This plan for 1015 Havre Ct is for a house size more than 3800 sf ft, 1 story and 44.429% FAR, with a peak roof height of almost 20ft. Neighboring houses have roof lines ranging 15-17 ft. All designed specs are to the absolute max allowed not typically seen in any house in our entire neighborhood. (FAR max allowed is 45%, setbacks on all sides are reqd min, front yard impervious at 48.6% when max allowed is 50%)

1. Item 1: Size of house and FAR not in line with neighborhood norms.

Photo taken at 6:20pm on Sep 3. It shows even at that time currently we get sun at area being converted to sunroom from patio.

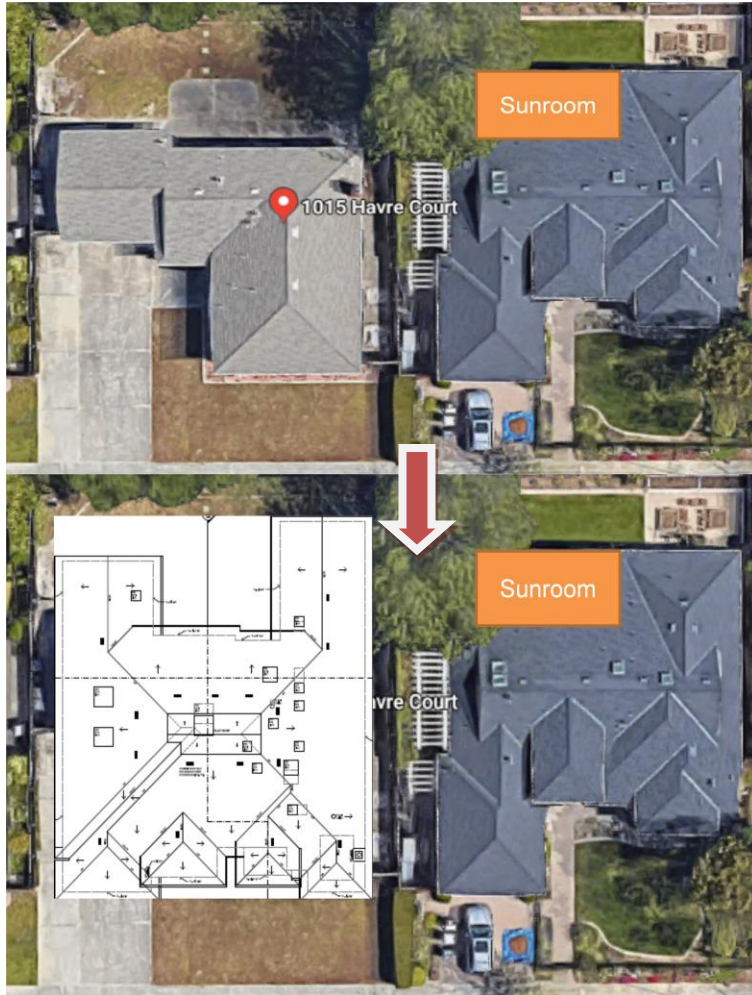
- a. The proposed roof height is a max of ~20 ft. The new house is also reducing the current setback on our side from existing 10ft to 6ft (with additional 1 ft reduction with a window bench). This brings this higher roof even closer to our side. This affects us in 2 ways
 - i. Currently our road Havre Ct slopes towards Wright Ave. This already brings the 1015 Havre Ct current 15 ft roof almost very close in height to our 1011 Havre Ct ~17 ft highest point. See attached photo showing current roof layouts.

Now imagine 1015 Havre Ct moving up 5 ft higher at its highest point and also closer to our side with the reduction in setback on our side. (Marked in the red lines)

- b. We have a west facing sunroom which will be completed later this year (all permits already approved by Sunnyvale in Spring this year). With this larger house closer to us on our west side, this new room for us will lose its utility very soon. In the absence of any shadow analysis through seasons on our property by this, we can only estimate the effect for us, but we believe we will lose the sun in the sunroom in winters with lower sun angles - which is when we plan to reap the benefits of the sunroom the most.

This will be likely lost completely in winter with the high roof and extended house facing it.

3. Item 3 : Effect of this massive demolition and construction on our trees on the side shared with them

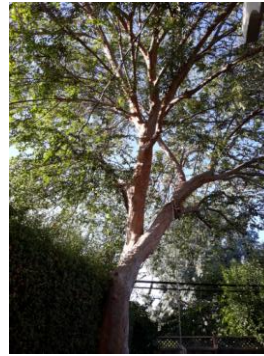
We also have a very mature garden with many old trees and greenery along the fence, and would like to get some guarantee that this big construction will not affect it with any runoff etc since the house edge will be only just over only 5 ft from our fence line. We would like the city to require some sort of assurance since the trees are very dear to us and we cannot afford to lose these old trees which are along the fence edge. We like greenery on our yard and cannot lose that to any construction on the other side.
